From: "Craig Caplick - NEON" <Craig@consultneon.com.au>
Sent: Thu, 28 May 2026 11:20:01 +1000
To: "Dee Petersen" <deep@msc.qld.gov.au>
Cc: "Carl Ewin" <CarlE@msc.qld.gov.au>; "Brian Millard" <BrianM@msc.qld.gov.au>
Subject: RE: Request for Operational Works Application Information Confirmation -
Amaroo Stage 15
Attachments: 048-2501-15-Amaroo Stage 15_260528_Add Lot 360.pdf

AMAROO ESTATE SUBDIVISION, MAREEBA

STAGE 15

AMAROO ESTATE SUBDIVISION
STAGE 15
SEWERAGE PLAN

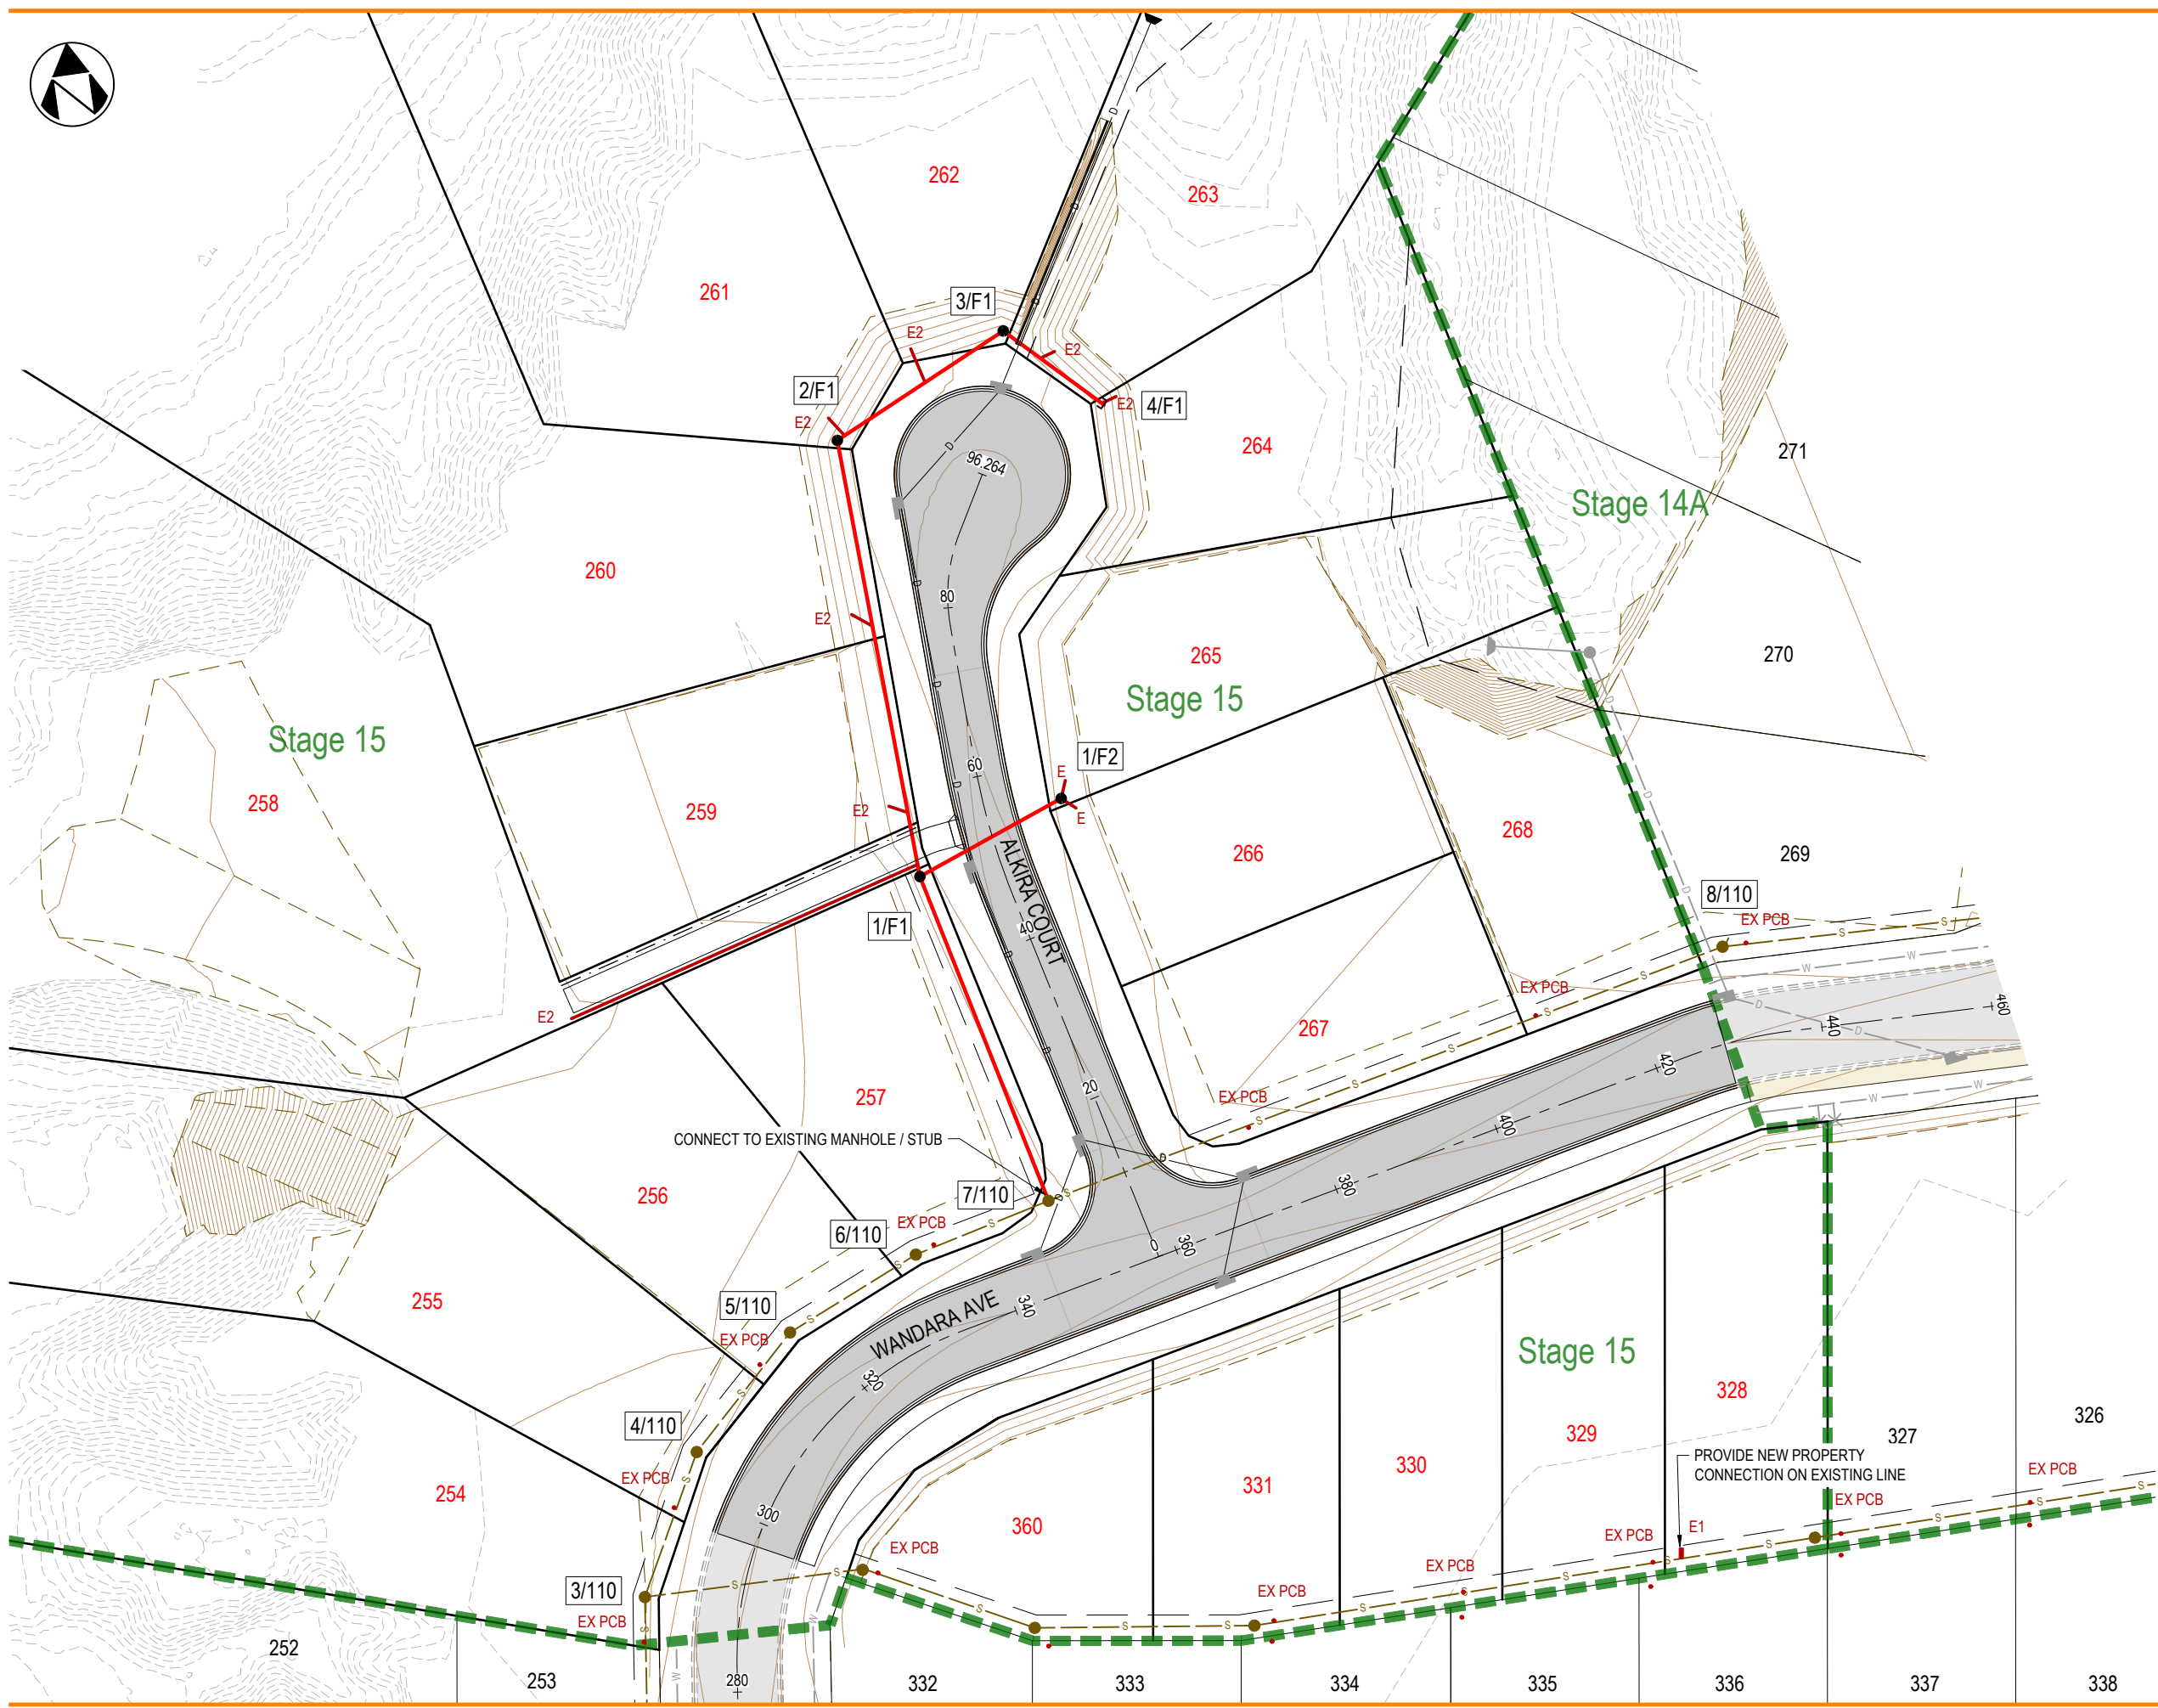
Rev	Date	Revision Notes
C	28.05.26	ADDITIONAL LOT 360 ADDED
B	23.12.25	STORMWATER REVISED
A	30.10.25	INITIAL ISSUE

AMAROO ESTATE SUBDIVISION
STAGE 15
WATER RETICULATION

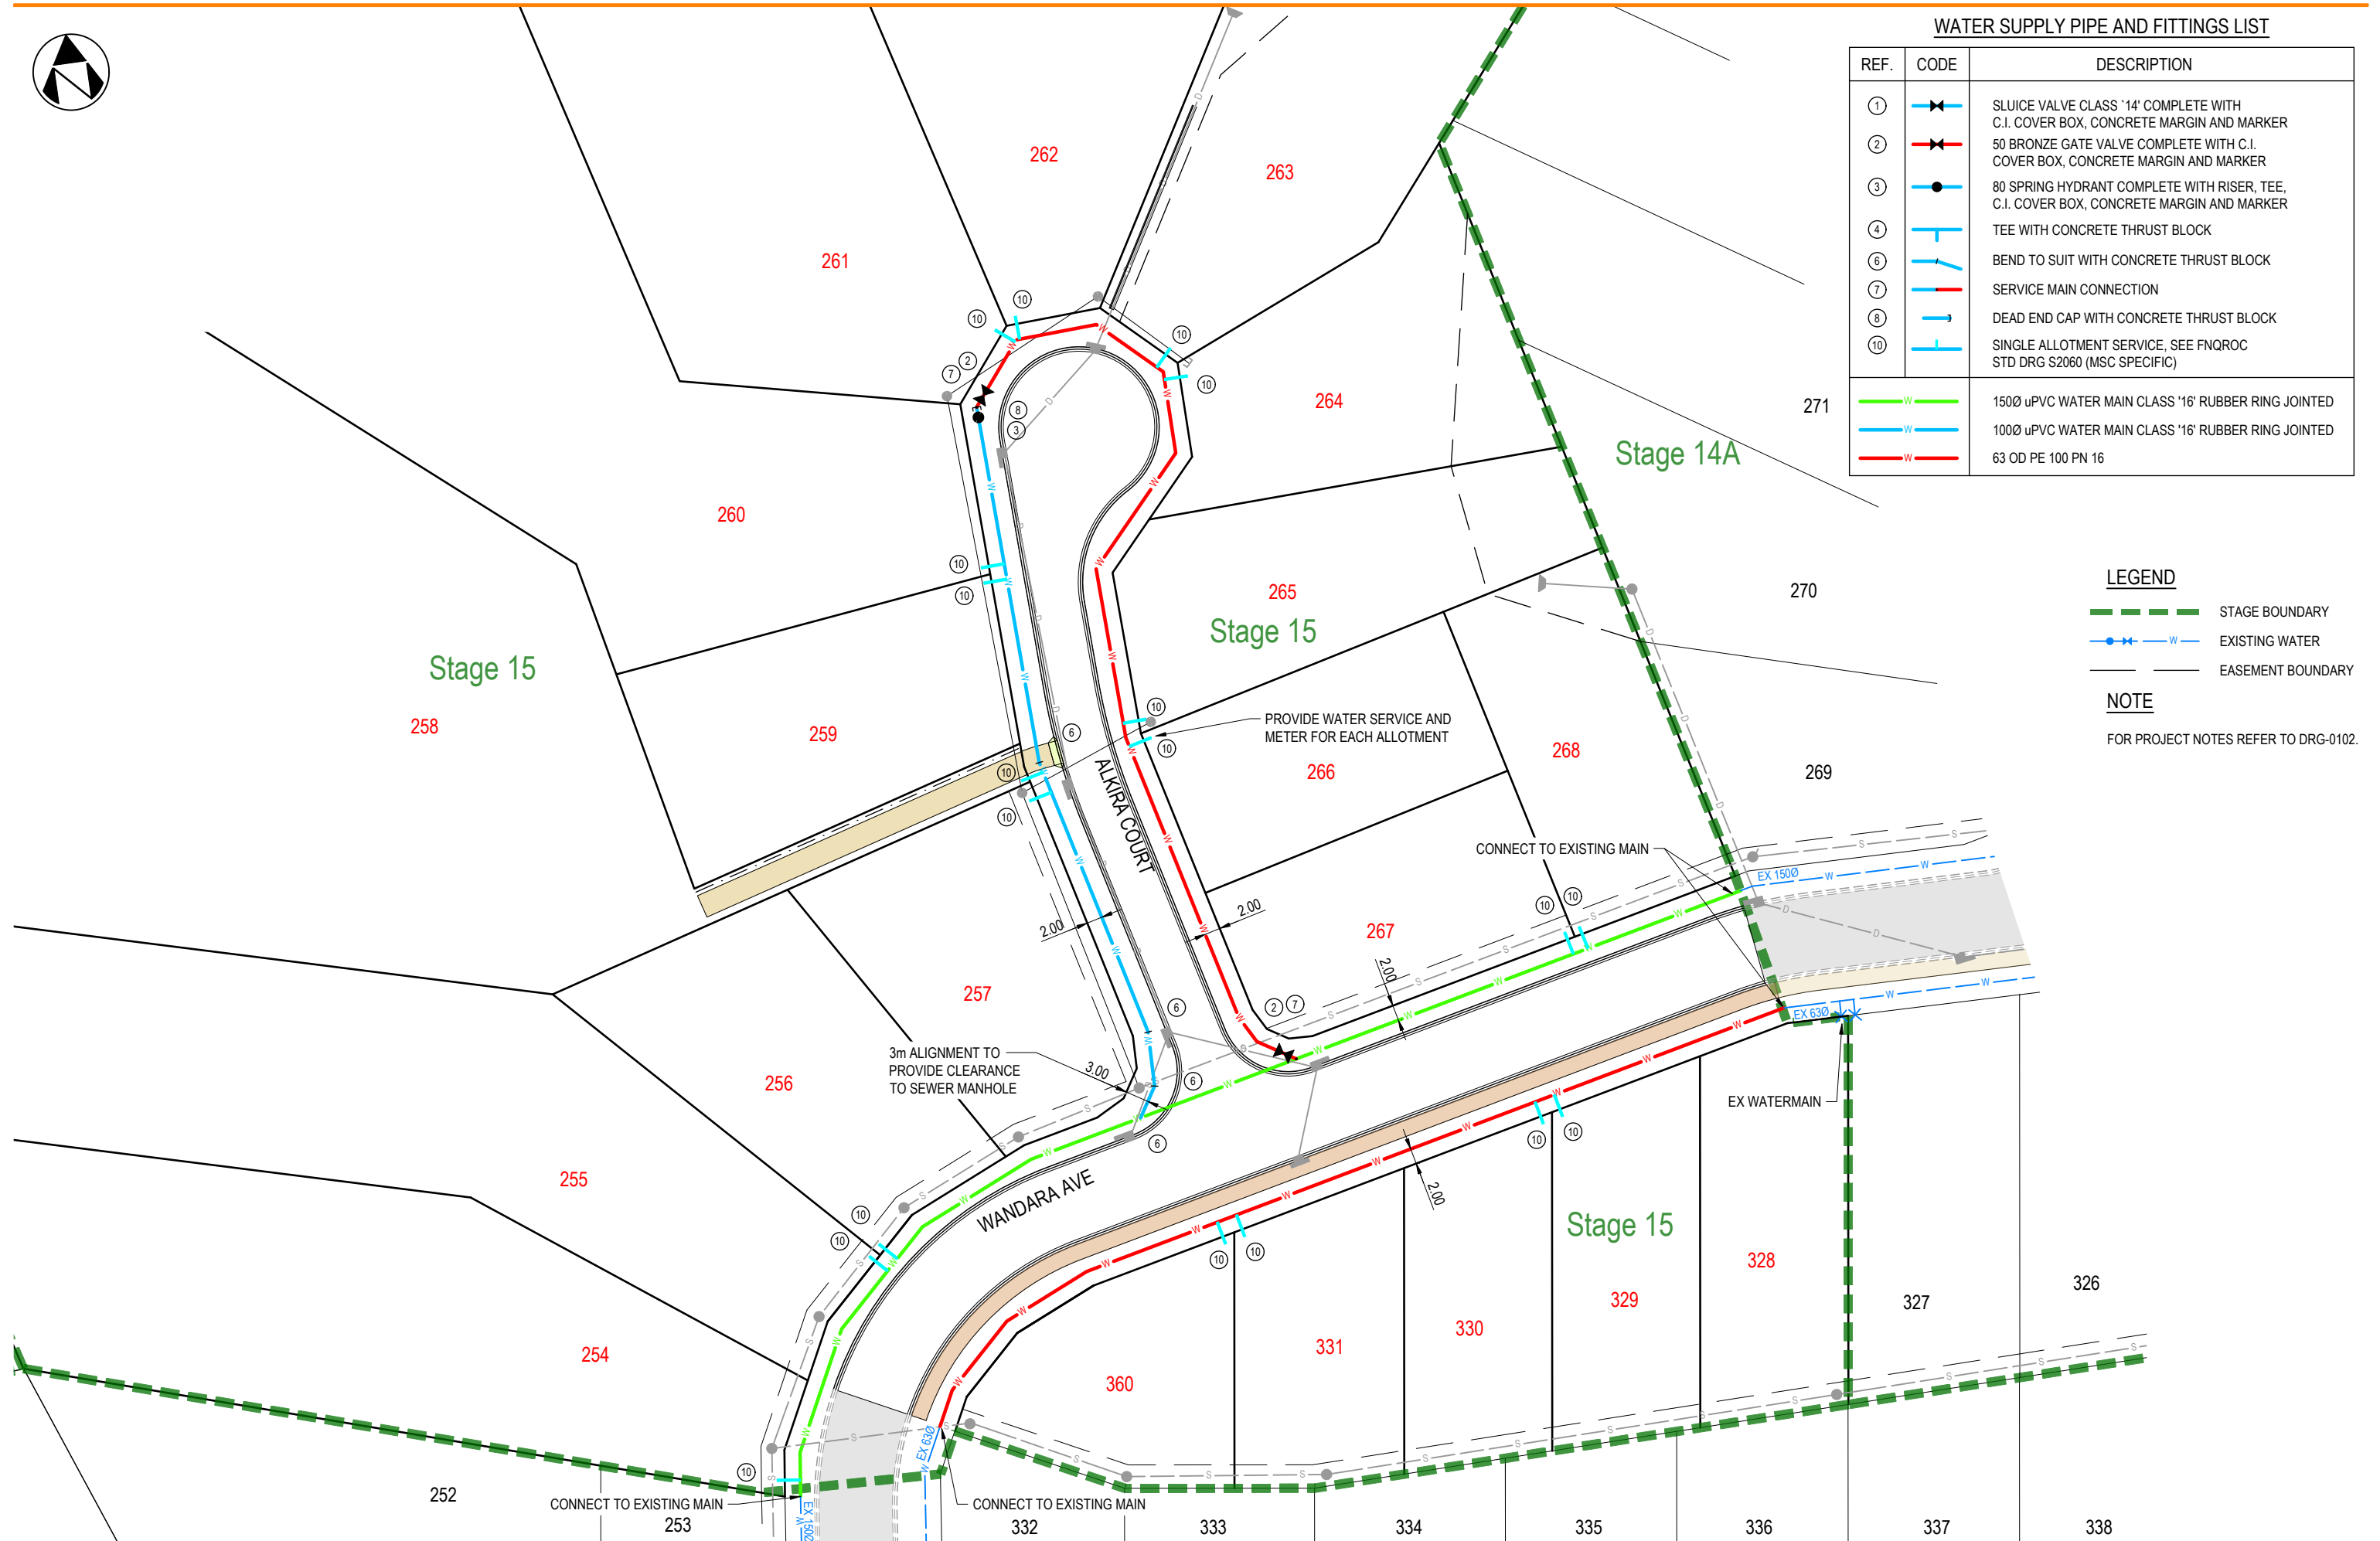
Rev. Date. Revision Notes
 C 28.05.26 ADDITIONAL LOT 360 ADDED
 B 23.12.25 STORMWATER REVISED
 A 30.10.25 INITIAL ISSUE

AMAROO ESTATE SUBDIVISION
 STAGE 15
 SITE BASED STORMWATER MANAGEMENT PLAN
 PHASE 1: TOPSOIL STRIPPING

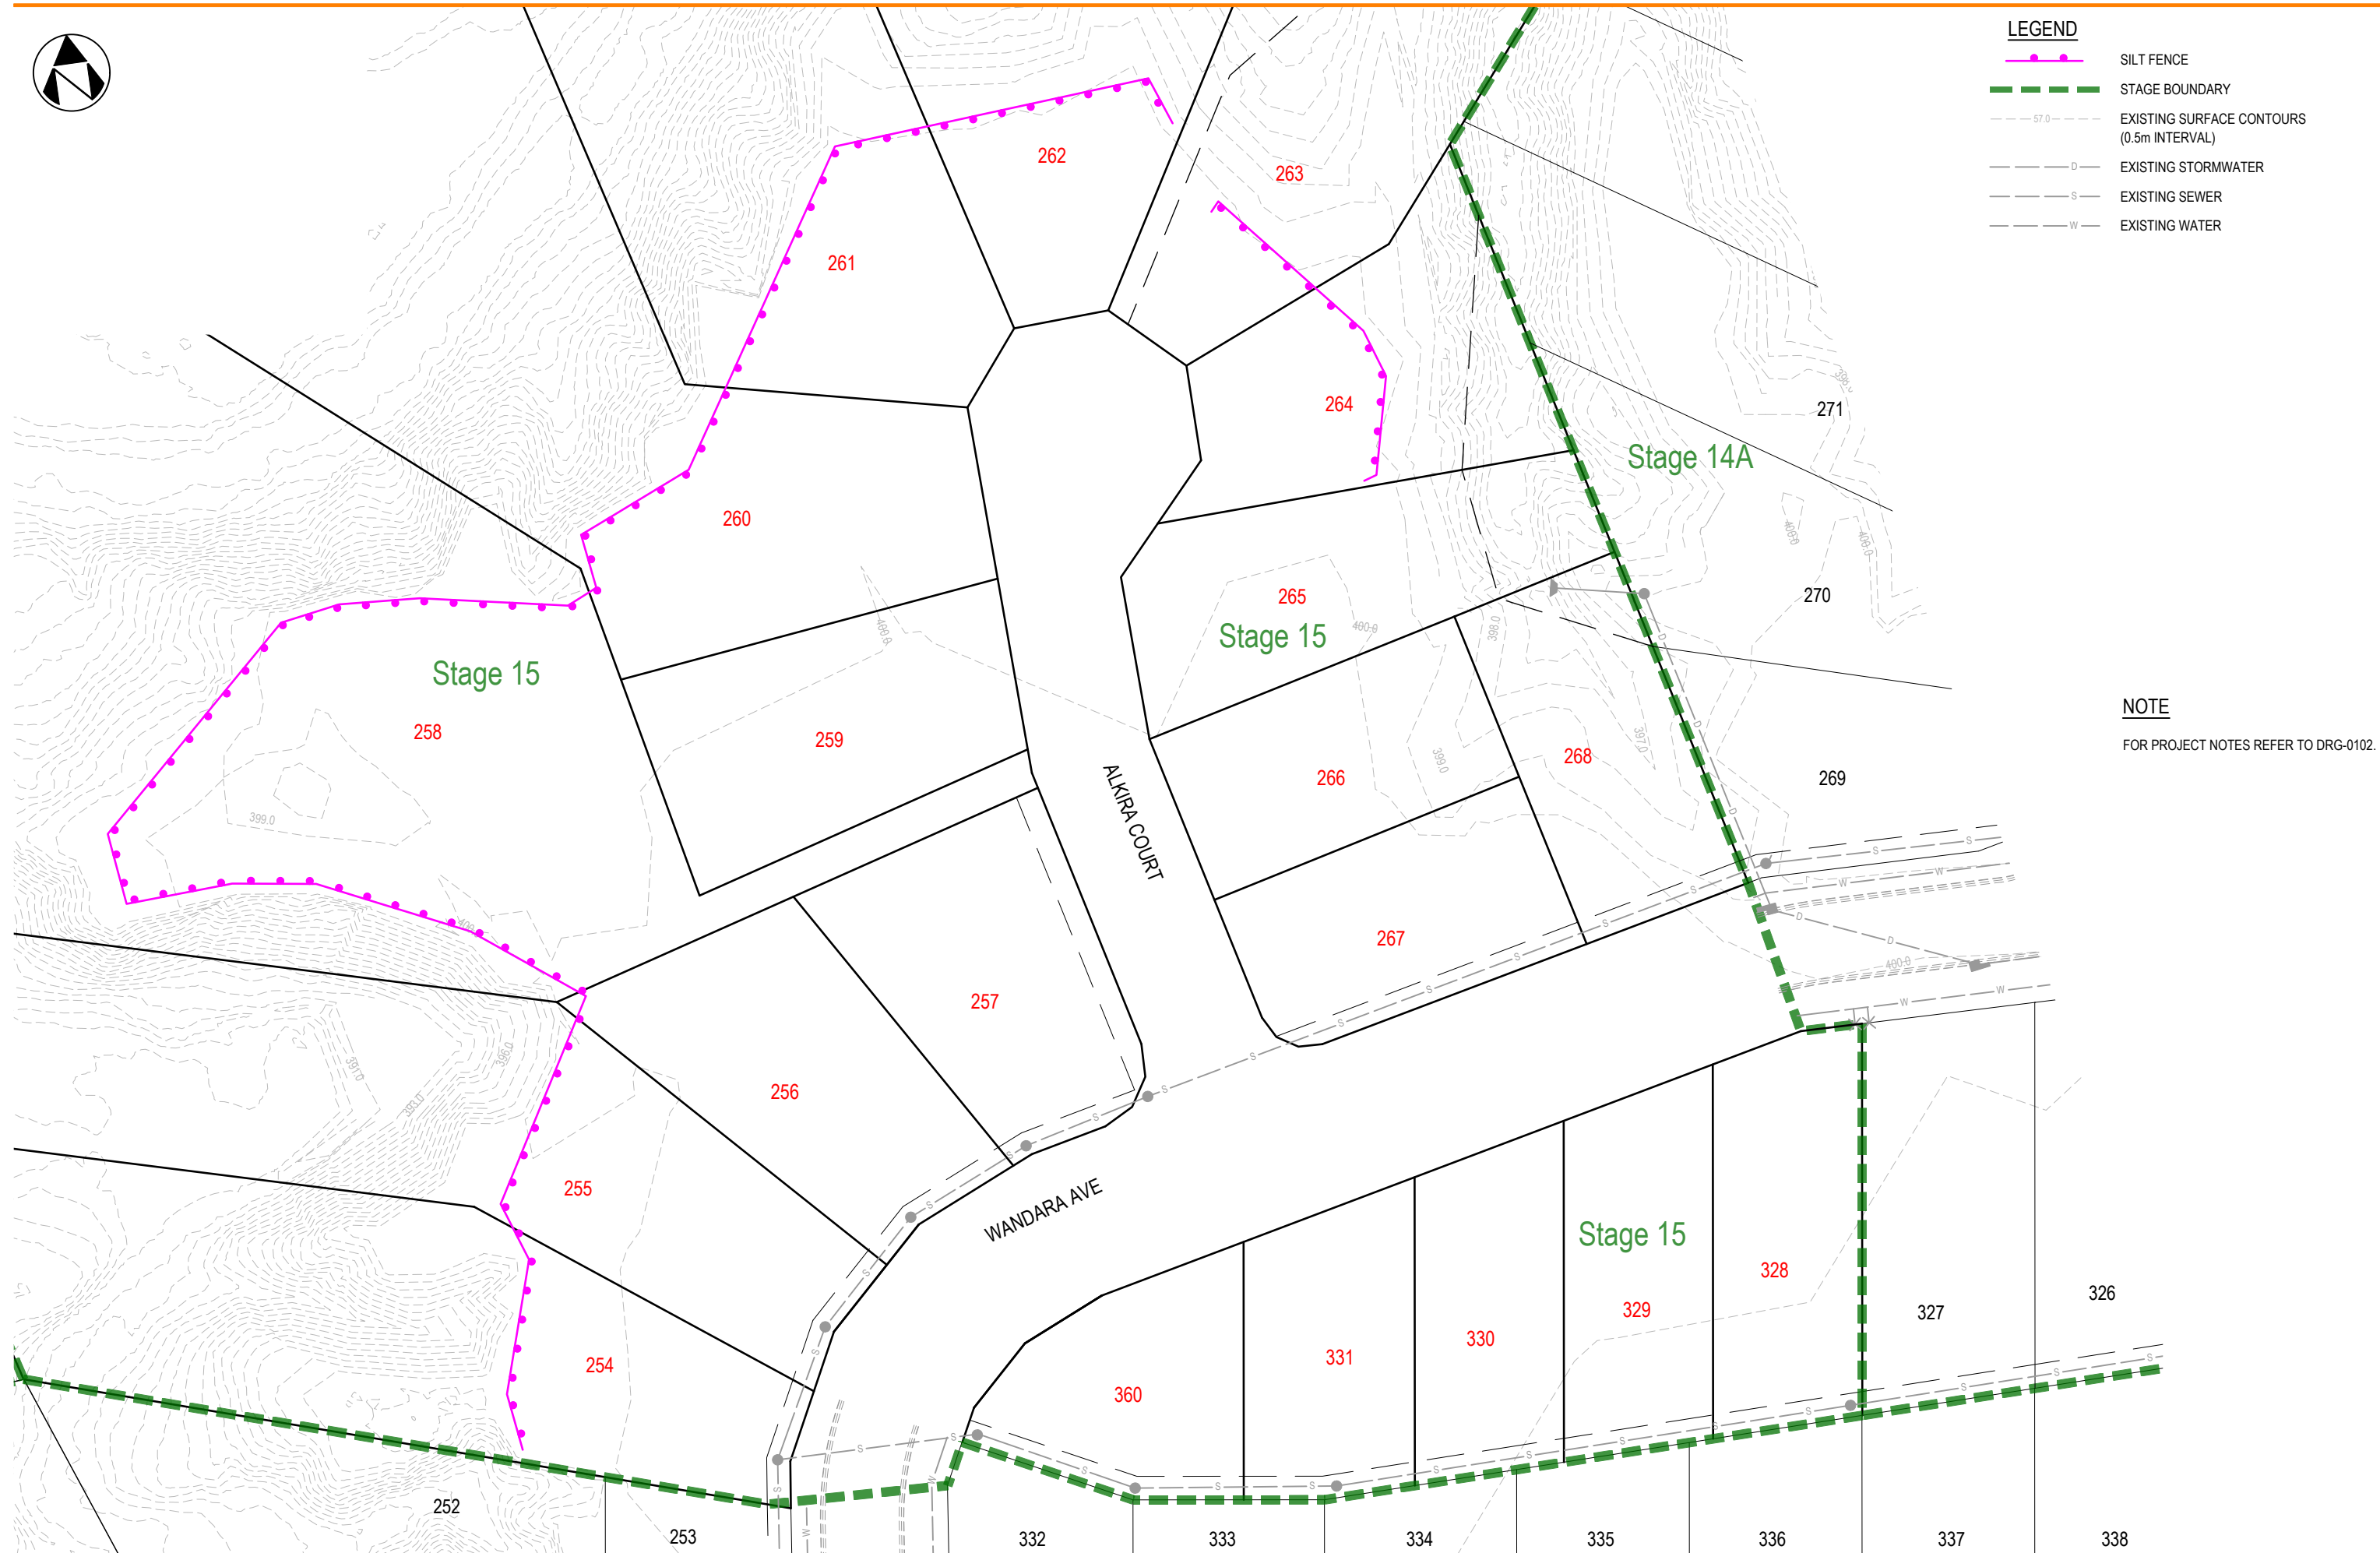
Rev. Date. Revision Notes
 B 28.05.26 ADDITIONAL LOT 360 ADDED
 A 30.10.25 INITIAL ISSUE
